FIFC report 14-Oct-208

(Based on the FIFC meeting held on 3-Oct-08)

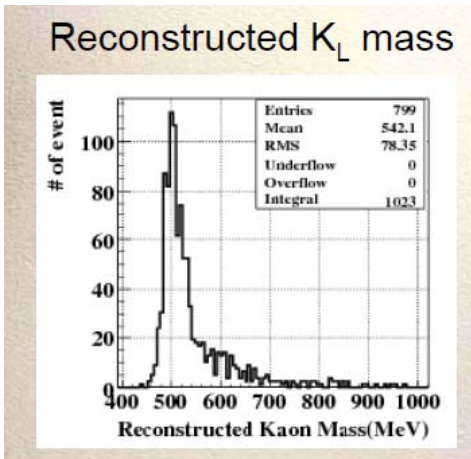
The magnet has then been moved to J-PARC site. For the transportation, a part of the magnet yoke was disassembled and the coil unit was once disassembled as shown in the photo above. During the stand alone test of the coil at Toshiba, it was found that the coil has an earth fault newly developed. The coil was investigated in detail and the fault was identified at the most inner side of the coil assembly where the repair is almost impossible. The coil assembly was finally fixed by disconnecting one coil block out of six. The protection resistor was changed from 3 to 2 ohm to avoid an excessive high voltage to ground on occasion of possible quench. Because of the disconnection, the central magnetic field is reduced from 2.7T to 2.48T with the maximum rating current of 400A.

FIFC discussed the situation of the modified SKS magnet and basically agreed on its proposed use at J-PARC. Some worries were raised about the use of the calculated map in the physics analysis. FIFC suggests further investigation of the reliability of the calculated to improve the performance. The other concern is the cause of the coil earth fault. Although the mechanism is yet unknown, it was reported that the fault developed after transporting the magnet to Toshiba and the transportation and disassembling of

the magnet are considered as the cause. Reducing the number of quenching and/or thermal cycling of the magnet could be effective to avoid the further development of the coil faults. It is recognized that the new cooling system enables to keep the liquid helium at a low temperature for a long time without the assistance of operation shifters and it is useful to reduce the number of warming of the coil. FIFC suggests further investigation of the cause of the coil faults with the possible improvement in its detection.
